Access Compliance Report

Public Rights-of-Way

Intersection ID: 22011	Main Street: SOUTH_BV	Cross Street: HILL_RD	Location: NE
ADA ID: F8D38D466191	Ramp Type: PerpDiag	Initial Pass/Fail: Fail	Overall Compliance: No
Severity Score: 18.75			
Codes/Mitigation Info/Possible Solution		Field Measurements/Component Compliance

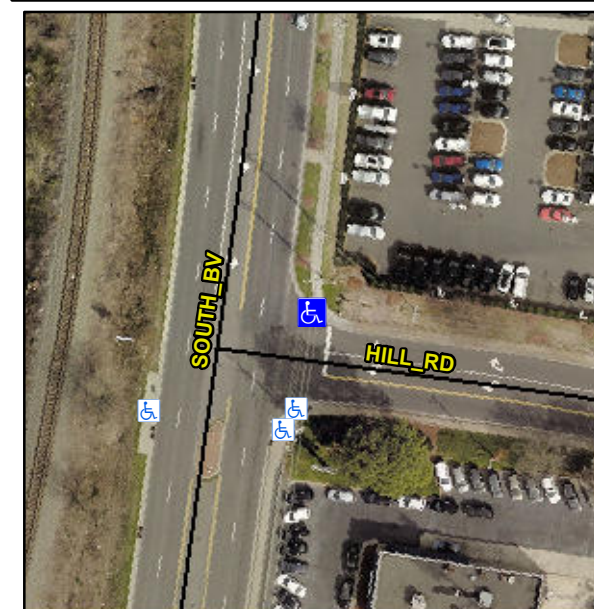
R304.5.1, R304.5.3

Compliance	Description	Data	Compliance	Description	Data
N/A	Ramp Length (in)	71.0	Yes	Ramp Slope (%)	5.9
No	Ramp Width (in)	35.0	No	Ramp XSlope (%)	2.2
N/A	Flare Type LT	N/A	N/A	Flare Type RT	N/A
N/A	Flare Slope LT (%)	N/A	N/A	Flare Slope RT (%)	N/A
N/A	Flare Traversable LT?	N/A	N/A	Flare Traversable RT?	N/A
N/A	Landing Length (in)	N/A	N/A	DWS Provided?	N/A
N/A	Landing Width (in)	N/A	N/A	DWS Contrast?	N/A
N/A	Landing Slope (%)	N/A	N/A	DWS Length (in)	N/A
N/A	Landing X Slope (%)	N/A	N/A	DWS Full Width?	N/A
N/A	Landing Curb? (Y/N)	N/A	N/A	DWS Offset (in)	N/A
N/A	Shared Landing?	N/A			
N/A	Gutter Ponding?	N/A	N/A	Gutter Slope (%)	N/A
N/A	Gutter Lip Ht (in)	N/A	N/A	Gutter X Slope (%)	N/A
N/A	Painted X Walk1?	No	N/A	Painted X Walk2?	No
	X Walk 1 Direction	To W		X Walk 2 Direction	To S
N/A	X Walk 1 Width (in)	N/A	N/A	X Walk 2 Width (in)	N/A
	X Walk 1 Slope (%)	1.6		X Walk 2 Slope (%)	2.1
	X Walk 1 X Slope (%)	1.3		X Walk 2 X Slope (%)	3.2

Remove & Replace Curb Ramp With Two New Directional Ramps or Equivalent.
